# Access Compliance Report

## Public Rights-of-Way

Intersection ID: 19805	Main Street: MORRISON_BV	Cross Street: SOUTH_PARK_DR	Location: SE
ADA ID: 480973BB7866	Ramp Type: Perp	Initial Pass/Fail: Fail	Overall Compliance: No
Severity Score: 33.75			
Codes/Mitigation Info/Possible Solution		Field Measurements/Component Compliance

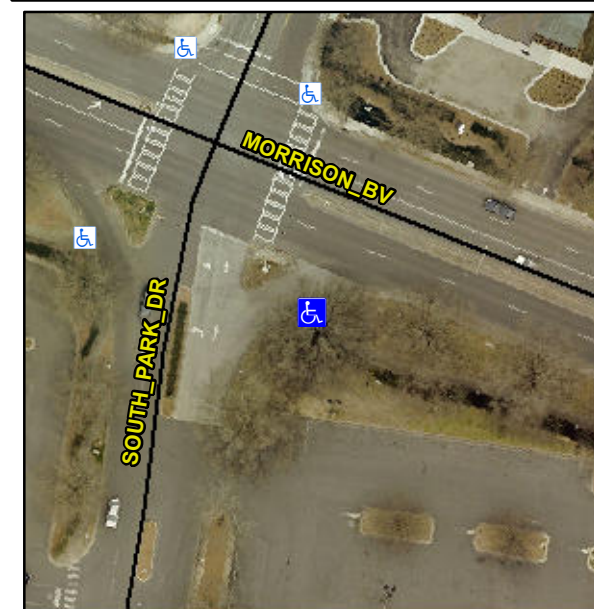
**Not Found, R304.5.1, R304.2.2**

Compliance	Description	Data	Compliance	Description	Data
N/A	Ramp Length (in)	51.0	No	Ramp Slope (%)	17.9
No	Ramp Width (in)	46.0	Yes	Ramp XSlope (%)	1.7
N/A	Flare Type LT	N/A	N/A	Flare Type RT	N/A
N/A	Flare Slope LT (%)	N/A	N/A	Flare Slope RT (%)	N/A
N/A	Flare Traversable LT?	N/A	N/A	Flare Traversable RT?	N/A
N/A	Landing Length (in)	N/A	N/A	DWS Provided?	N/A
N/A	Landing Width (in)	N/A	N/A	DWS Contrast?	N/A
N/A	Landing Slope (%)	N/A	N/A	DWS Length (in)	N/A
N/A	Landing X Slope (%)	N/A	N/A	DWS Full Width?	N/A
N/A	Landing Curb? (Y/N)	N/A	N/A	DWS Offset (in)	N/A
N/A	Shared Landing?	N/A			
N/A	Gutter Ponding?	N/A	N/A	Gutter Slope (%)	N/A
N/A	Gutter Lip Ht (in)	N/A	N/A	Gutter X Slope (%)	N/A
N/A	Painted X Walk1?	No	N/A	Painted X Walk2?	N/A
	X Walk 1 Direction	To NW		X Walk 2 Direction	N/A
N/A	X Walk 1 Width (in)	N/A	N/A	X Walk 2 Width (in)	N/A
	X Walk 1 Slope (%)	0.2		X Walk 2 Slope (%)	N/A
	X Walk 1 X Slope (%)	0.2		X Walk 2 X Slope (%)	N/A

**Remove & Replace Entire Ramp.**
